Mercedes-Benz

Campaign No. 2019070013, December 2019

SUBJECT: **Model C-class (205 platform), E-Class (213 platform), and E-Class Coupe (238 platform).**
Model Years 2015-2018
Replace Steering Rack

Figure 1

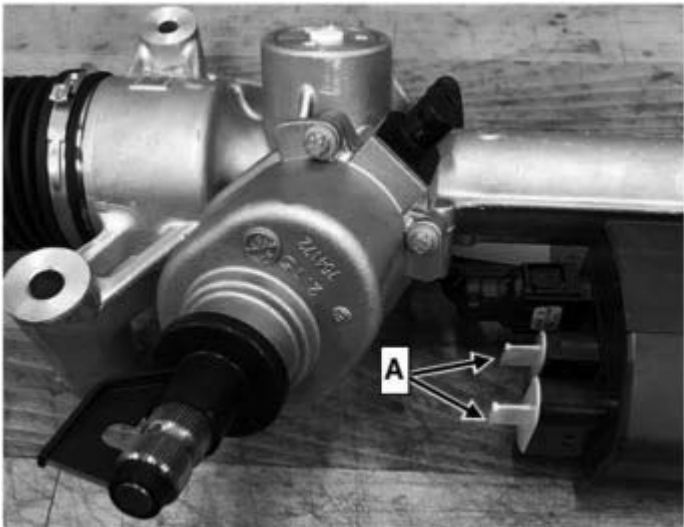
i To prevent dirt from entering the connector couplings or damage from ESD (electrostatic discharge), it is **absolutely essential** to fit the yellow dust caps (**A, Figure 1**) on the connector couplings of the steering gear to be returned. The **caps** from the **new** steering gear are to be used for this.
